To: INCITS Technical Committee T10  
From: Kevin Butt  
Date: March 9, 2007 7:25 pm  
Document: T10/06-462r4 — SSC-3: Keyless Copy

### 4.2.20.4 Keyless copy of encrypted data

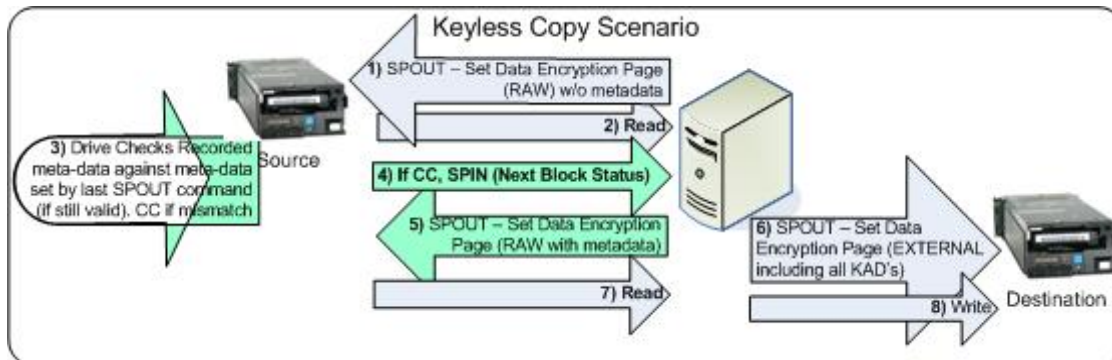
To describe the proposed solution I will use a picture and description of each step here and then the proposal portion will attempt to capture the necessary modifications/additions to make it work.

1. The application sends a SPOUT command setting the decryption mode to RAW. No KAD descriptors are sent.
2. The application begins reading.
3. The drive checks to see if any KAD descriptors are required for a successful RAW read to EXTERNAL write. If yes (the format requires KAD descriptors sent), then the drive returns a CC with the sense key set to DATA PROTECT, and the additional sense code set to INCORRECT DATA ENCRYPTION KEY. If no (the format contains all data within the block), the drive returns the read data and skips to step 6.

4. The application sends a SPIN command requesting Next Block Status. This would potentially include KAD descriptor 0x03.
5. The application sends a SPOUT command setting the decryption mode RAW and the KAD descriptors to the KAD descriptors returned in step 4. Since the data manager is required to set the KAD descriptors (if there are any), there is an explicit action required.

6. The application sends a SPOUT command setting the encryption mode to EXTERNAL and, if step 4 was required, all the KAD descriptors returned in step 4.

7. The application reads data until finished or the next CC. If a CC is returned for incorrect data encryption key then go to step 4.
8. The application writes the data read ( either in step 7 or step 2).

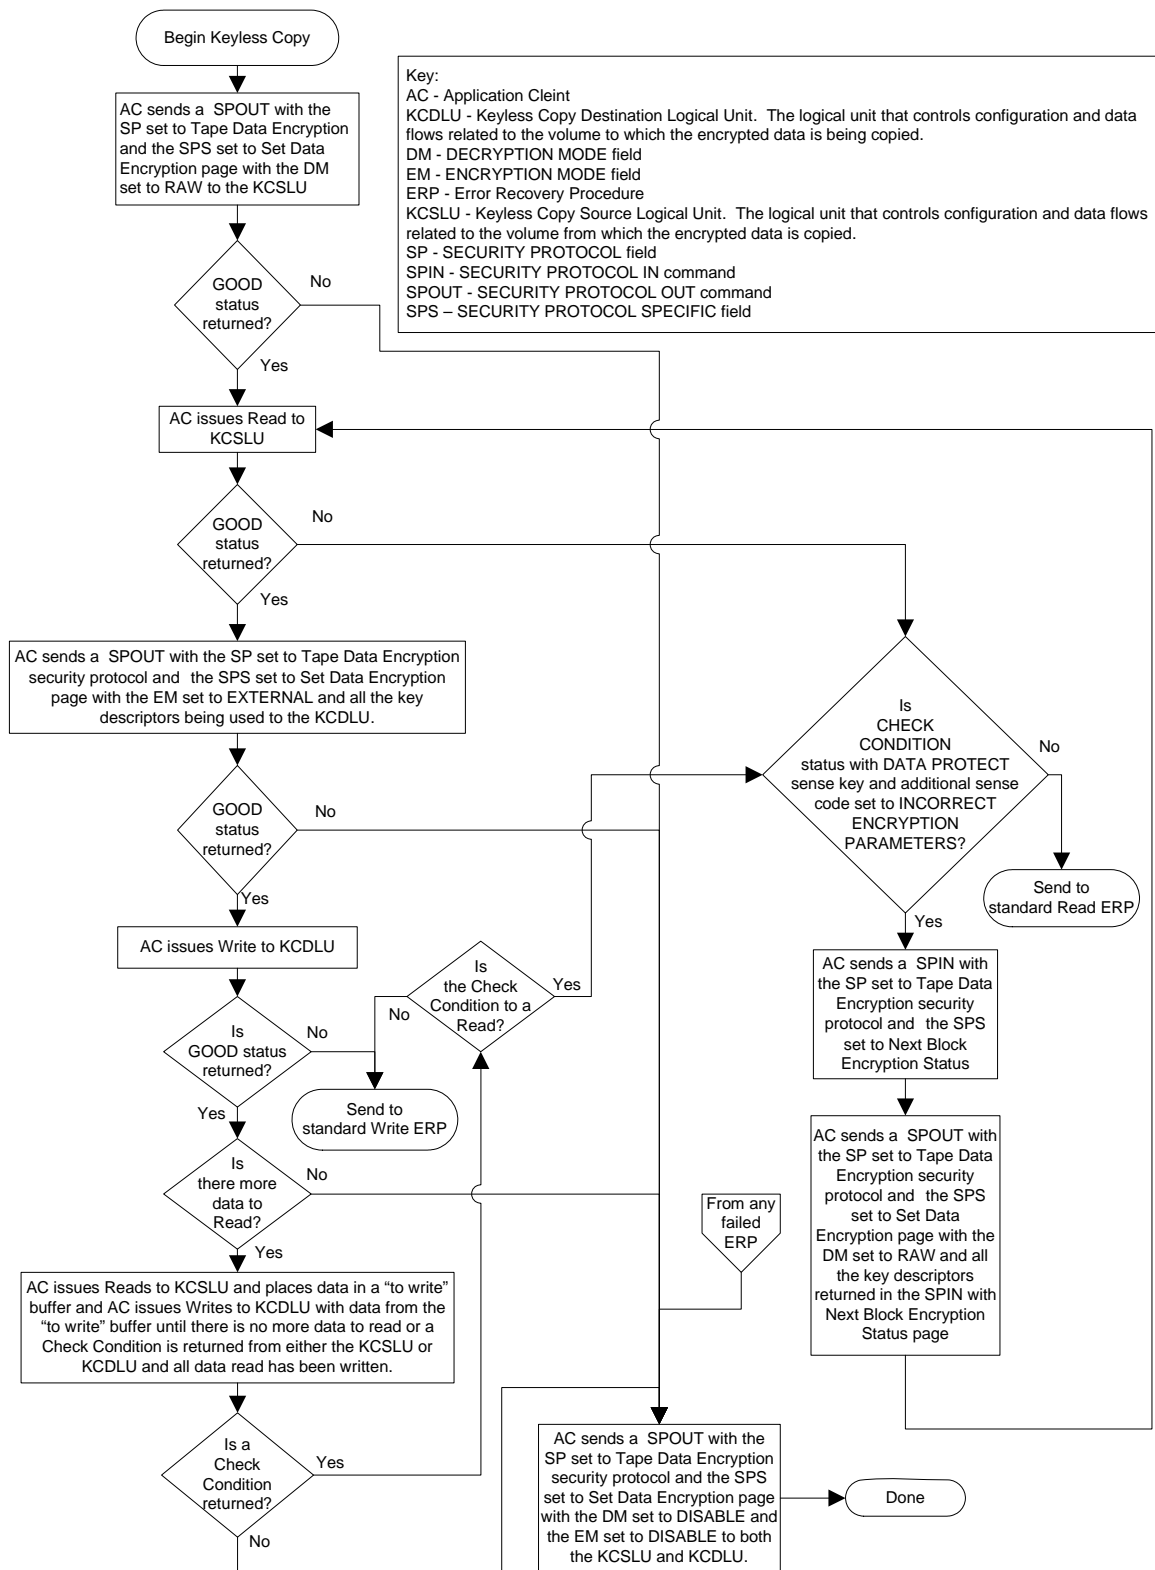
To accomplish a keyless copy operation an application client sets the KCSLU decryption mode to RAW and the KCDLU encryption mode to EXTERNAL. It then reads one or more logical objects from the KCSLU while writing those logical objects to the KCDLU. During this process if the KCSLU detects an event that requires modification to the KCDLU, the KCSLU returns a CHECK CONDITION status to the application client to notify it that some action is required. An example of this is shown in the informative flowchart in figure xx.
